Research Document 2011/086

**Science Technical Review of the draft
Environmental Impact Statement (EIS)
for Baffinland's Mary River Project**

R.E.A. Stewart¹, V. Lesage², J.W. Lawson³, H. Cleator¹ and K.A. Martin¹

Fig. 2. Arctic sea ice extent for February 2011 was 14.36 million square km (5.54 million square miles). The magenta line shows the 1979 to 2000 median extent for that month (from National Snow and Ice Data Center).

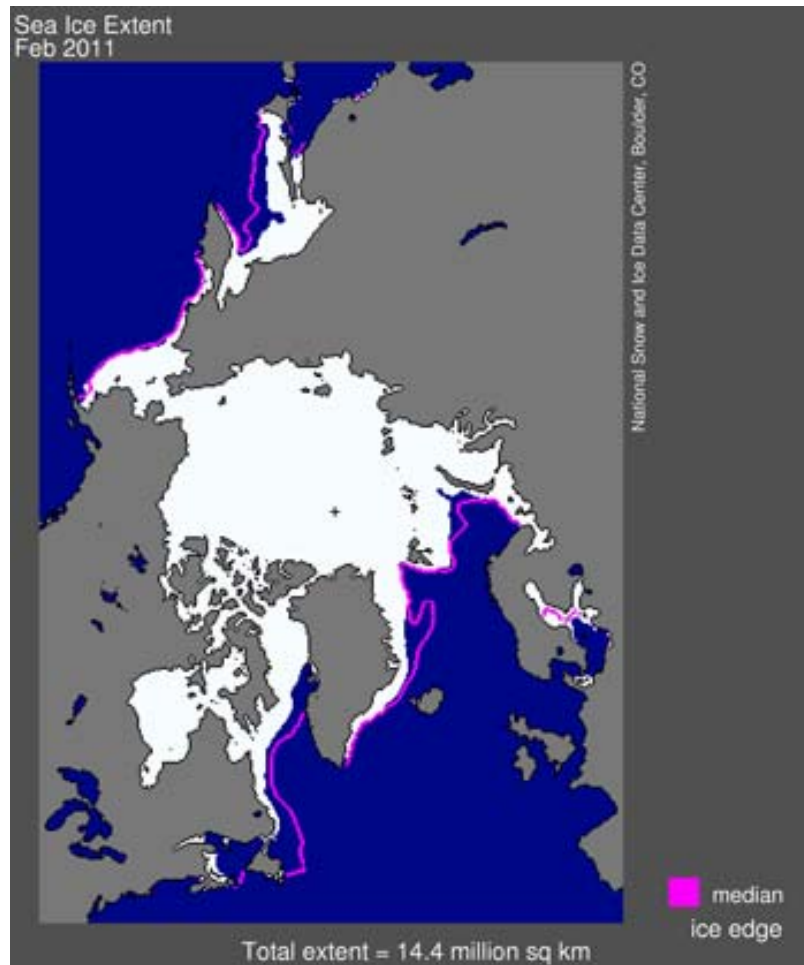
Information contradictory to the Proponent's stated preference was not considered in the alternative ports assessment. Enfotec acknowledges that climate change may lead to different ice regimes, but assumes that these changes will apply in a uniform manner to all of the study sites being examined (App. 3F-1:41). This may not be the case: in 2011, reduced sea ice extent (Fig. 2, NSIDC 2011) appears to favour northern ports more than the Foxe Basin option.

Conversely, while freeze-up was delayed 6-8 weeks in Hudson Bay and Hudson Strait, and ice cover in January 2011 was 36% of normal in Hudson Strait, Davis Strait and the northern Labrador Sea, it was only about two weeks late and reached 60% of average cover in Baffin Bay and Davis Strait, although there was virtually no ice in eastern Baffin Bay (EC 2011). Average thickness of ice deviated below average more in southern areas than Baffin Bay (EC 2011). Not only may the ice coverage data from 1992 presented in App. 3F-1 be irrelevant now, but regional differences in changing ice regimes need to be considered. *“So, the project will need to ensure decisions taken today consider the long-term affects of possible and or likely changes to the ice conditions along the different routes and port sites.”* (App. 3F-1:41)

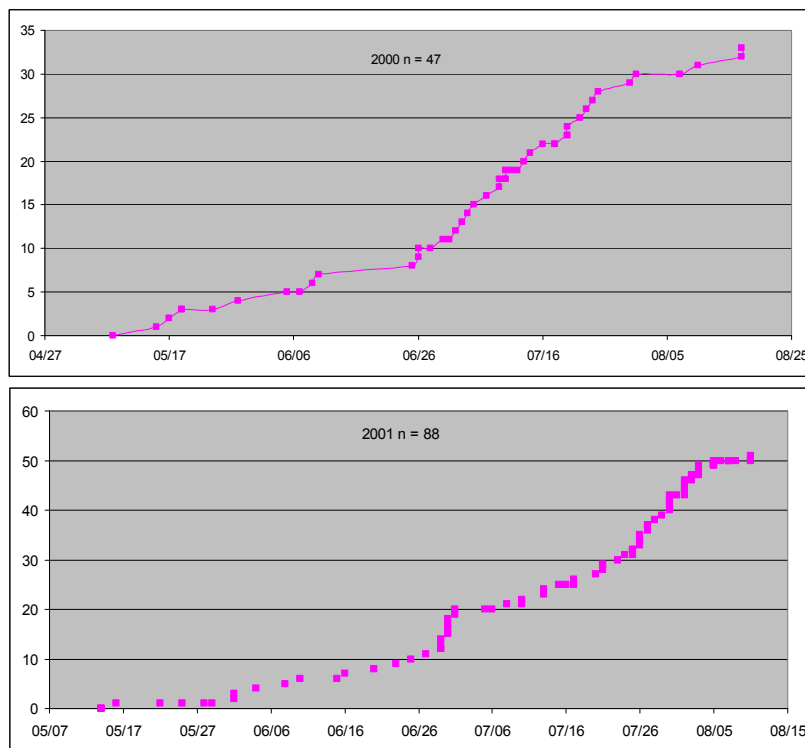
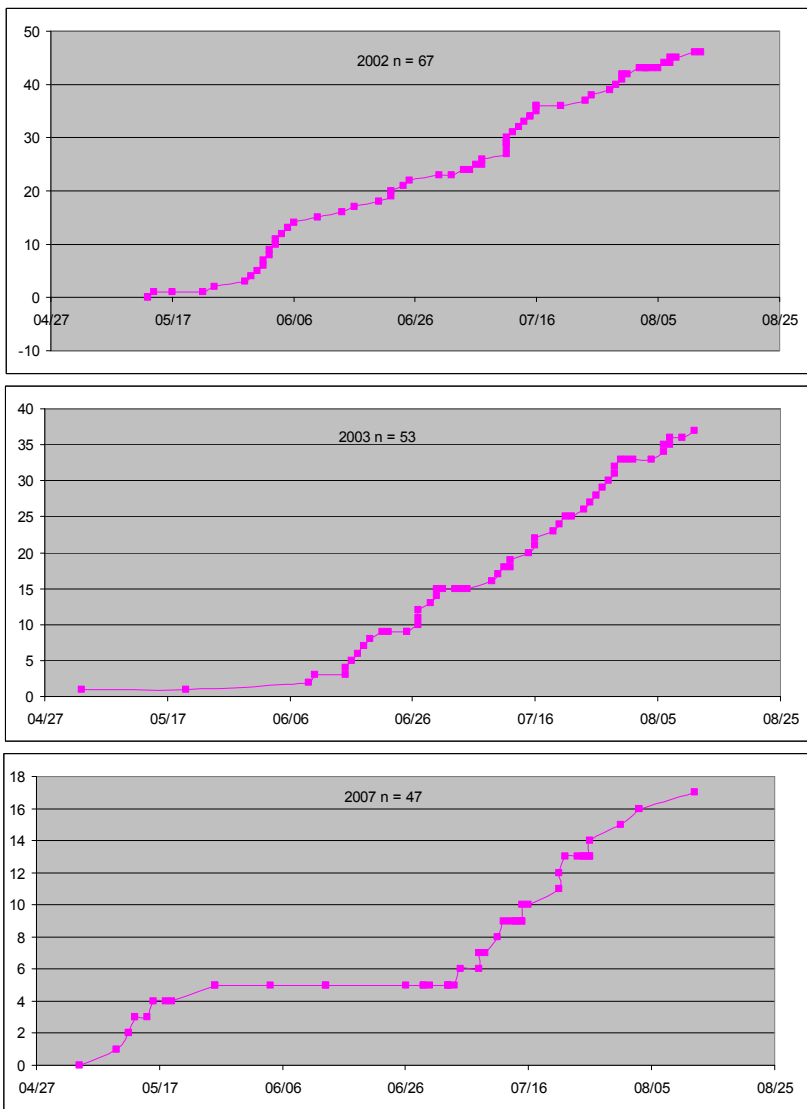
The Proponent expressed uncertainty about walrus' ability to habituate to overflights (Vol. 8:182) but did not discuss habituation of walrus to vessel traffic. In the presence of virtually constant noise, habituation is required to permit disturbance to be temporary. There is evidence that walrus at Round Island, Alaska, did not habituate to disruption within a summer season. The draft EIS cites Okonek et al. (2008) which is one in a series of annual Alaska Fish and Game (AFG) reports about wildlife on Round Island between 2000 and 2007²⁹. These reports tabulate disturbances and walrus responses. A preliminary examination of the data in these reports indicates that in the seasons for which there were 45 or more potential disturbances there was an absence of habituation in all years with the possible exception of 2001³⁰ (Fig. 2). There was a strong relationship between the number of departures from the haulout and the number of boat visits, and has been a small but not significant decline in maximum counts at Round Island. Although the proposed number of ship passages for the Mary River Project is vastly greater than at Round Island, these data are germane to assessing the potential for walrus to habituate to repeated disturbance. As described earlier for belugas, there is potential for walrus to experience chronic stress, whether they were to habituate or not, in response to ship noise.

Ice-breaking may be particularly disruptive to walrus, not due to the noise of the ice being broken but because of the operation of the vessel³¹. The Proponent agrees “*Walrus hauled out on ice may temporarily avoid an ore carrier transiting to and from Steensby Inlet by diving into the water, perhaps at distances ranging from 400–500 m up to several km.*” but concludes “*Walrus in the calving area are not expected to respond to ore carriers transiting through eastern Foxe Basin either during the ice-covered or open water period*” (Vol. 8:178). They based their conclusion on the only calving area being west of Rowley Island. But Fig. 4.18 in App. 8A-2 shows locations of numerous walrus within approximately 3-20 km of the proposed Steensby Inlet port (numbers of walrus present in a sighting are not indicated).
